WATER/WASTE - REPLACEMENT OF THE FORWARD GALLEY AND AFT LAVATORY FAUCET AERATORS (ADAMS RITE SERVICE BULLETINS AR90014-38-02 AND AR90060-38-02)

SL700-38-02
Page 1 of 3

WATER/WASTE – FAUCET ASSEMBLY – REPLACE EXISTING AERATOR,
PN 33184-1, WITH AERATOR, PN 33184-3.

AR90014-38-02

Figure 1. Removal/Installation of Aerator

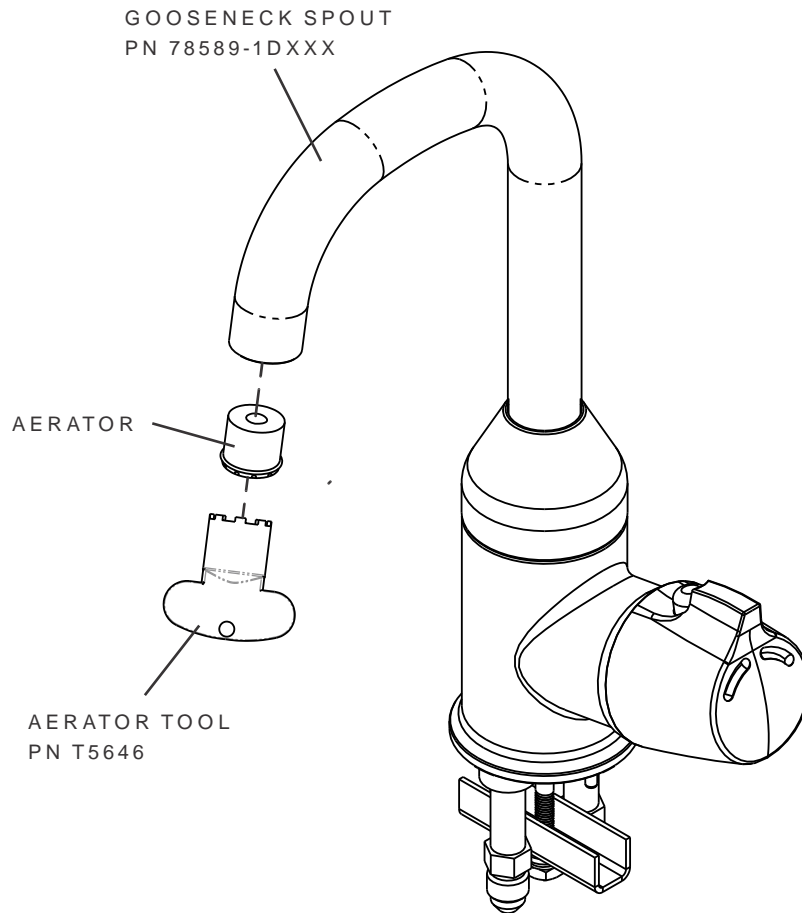
A. Removal of Existing Aerator

NOTE: Refer to Figure 1.

- (1) Use an aerator tool, PN T5646, to remove the existing aerator, PN 33184-1, from gooseneck spout, PN 78589-1DXXX. Discard the aerator.

B. Installation of New Aerator

NOTE: Refer to Figure 1.

- (1) Use an aerator tool, PN T5646, to install the new aerator, PN 33184-3, on gooseneck spout.

Figure 2. Installation of Modification Label, PN 91-008828-3
(Sheet 1 of 2)

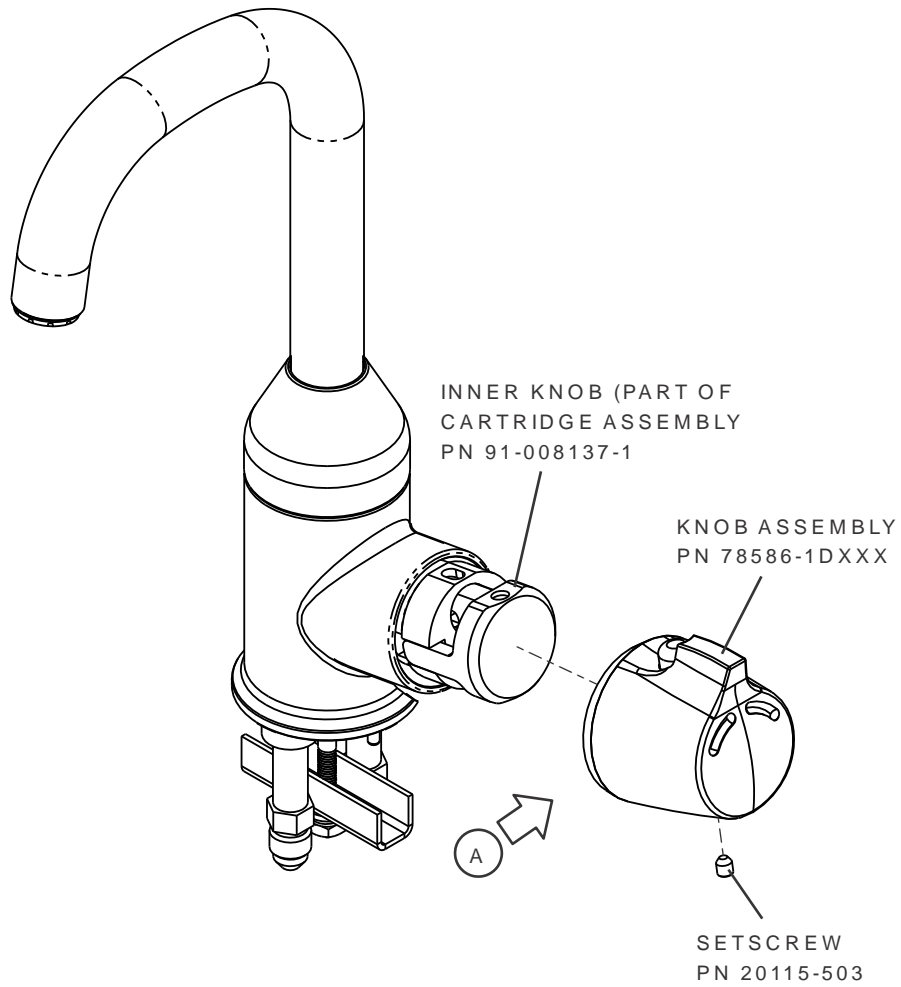
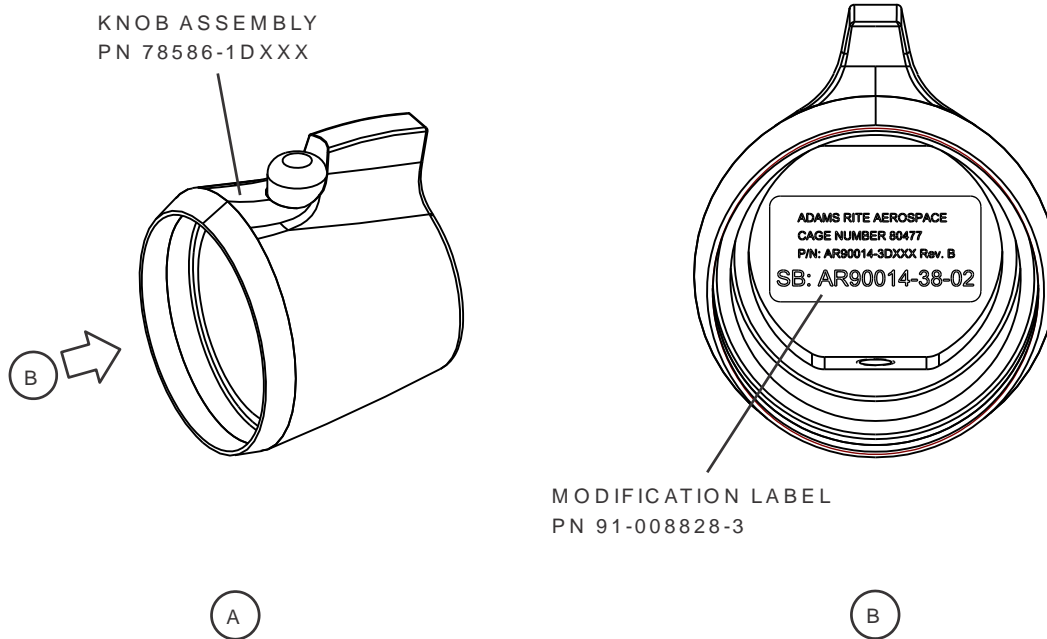
C. Installation of Label

NOTE: Refer to Figure 2.

- (1) Remove the setscrew, PN 20115-503 and knob assembly, PN 78586-1DXXX, from inner knob (part of cartridge assembly, PN 91-008137-1).

- (2) Clean the area of knob assembly where modification label, PN 91-008828-3, will be installed with a disposable cleaning wipe moistened with isopropyl alcohol.
- (3) Dry the area by wiping with a disposable cleaning wipe and by blowing with clean, dry, compressed air at 5 to 10 psig (34.47 to 68.95 kPa).
- (4) Install the modification label, PN 91-008828-3, on knob assembly.
- (5) Install the knob assembly with setscrew on inner knob (part of cartridge assembly).

Figure 1. Removal/Installation of Aerator

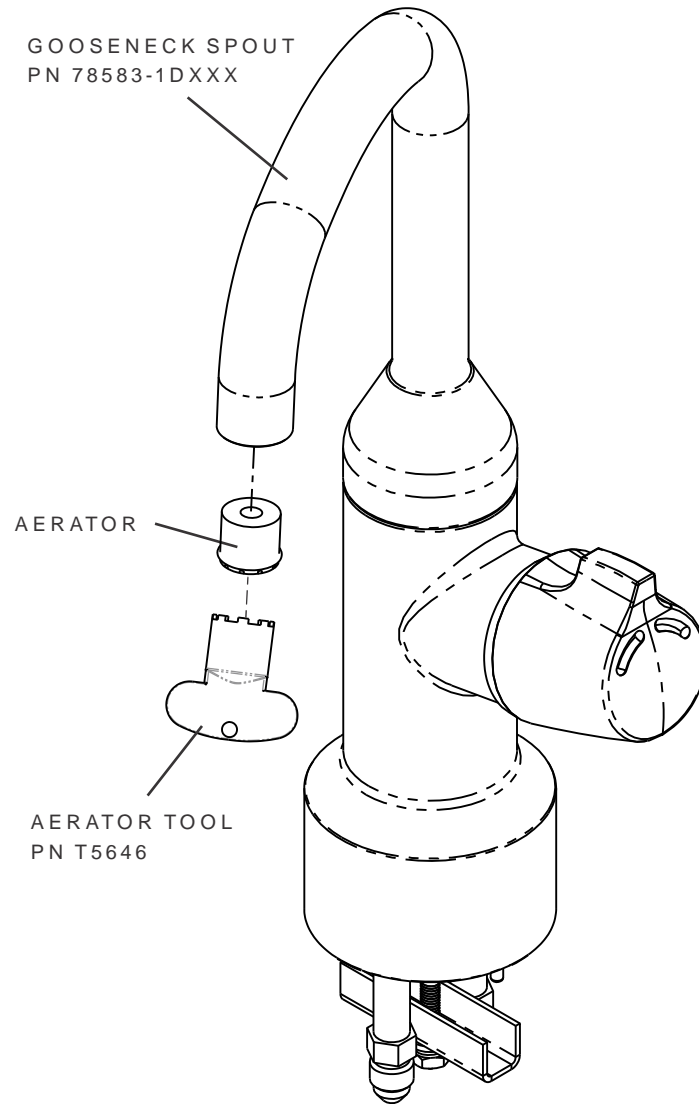
A. Removal of Existing Aerator

NOTE: Refer to Figure 1.

- (1) Use an aerator tool, PN T5646, to remove the existing aerator, PN 33184-1, from gooseneck spout, PN 78583-1DXXX. Discard the aerator.

B. Installation of New Aerator

NOTE: Refer to Figure 1.

- (1) Use an aerator tool, PN T5646, to install the new aerator, PN 33184-3, on gooseneck spout.

Figure 2. Installation of Modification Label, PN 91-008828-1
(Sheet 1 of 2)

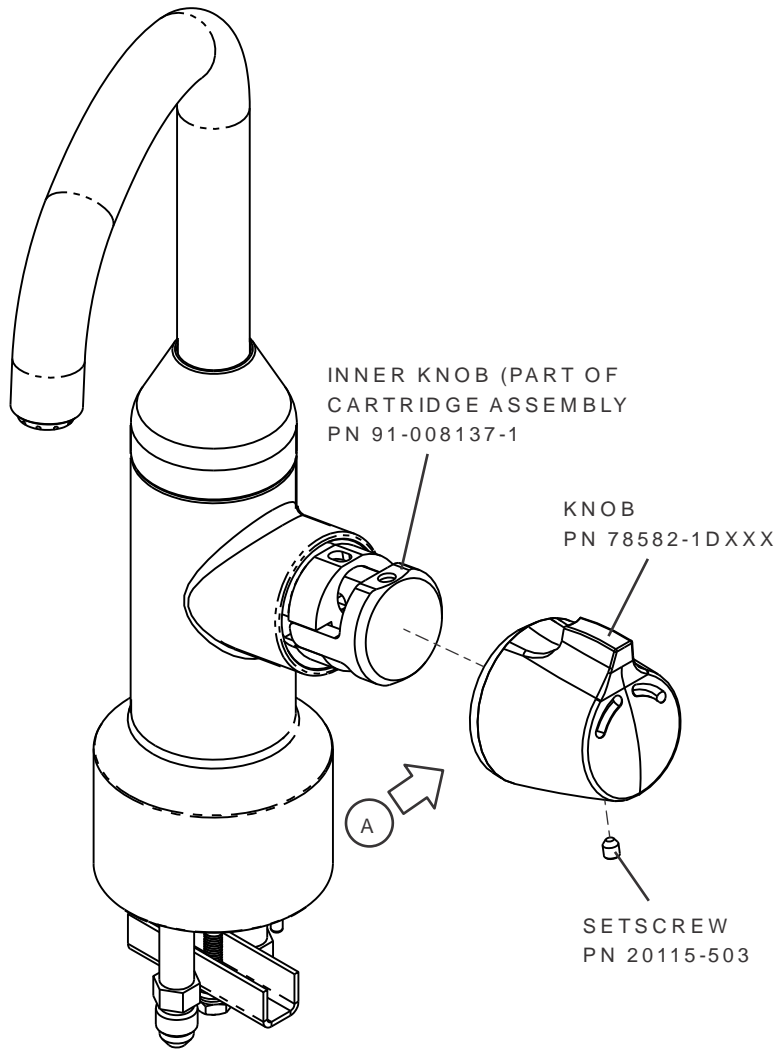
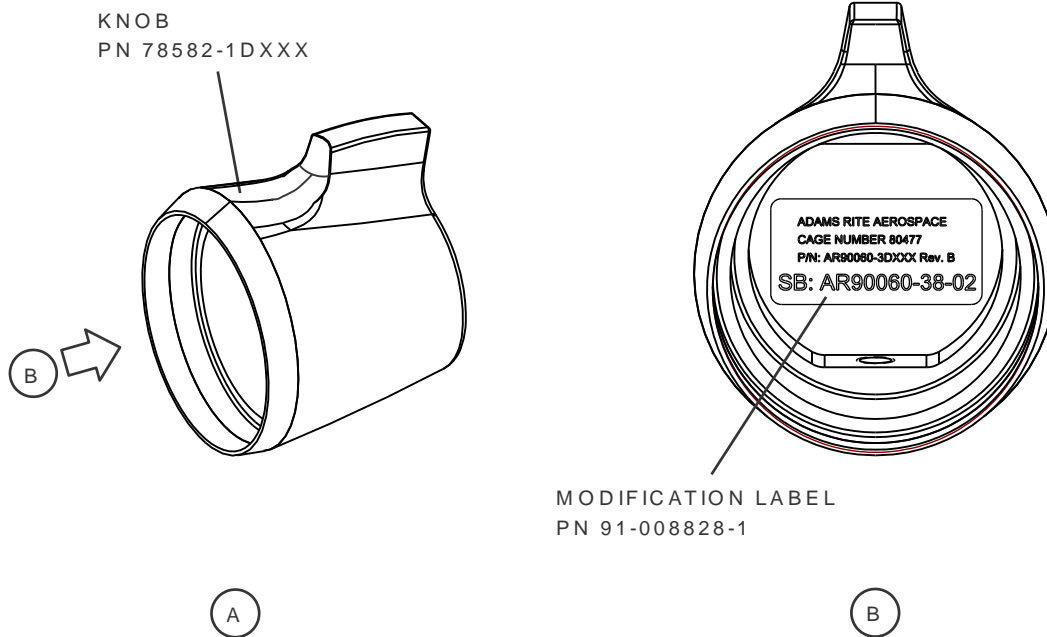
C. Installation of Label

NOTE: Refer to Figure 2.

- (1) Remove the setscrew, PN 20115-503 and knob, PN 78582-1DXXX, from inner knob (part of cartridge assembly, PN 91-008137-1).

- (2) Clean the area of knob where modification label, PN 91-008828-1, will be installed with a disposable cleaning wipe moistened with isopropyl alcohol.
- (3) Dry the area by wiping with a disposable cleaning wipe and by blowing with clean, dry, compressed air at 5 to 10 psig (34.47 to 68.95 kPa).
- (4) Install the modification label, PN 91-008828-1, on knob.
- (5) Install the knob with setscrew on inner knob (part of cartridge assembly).
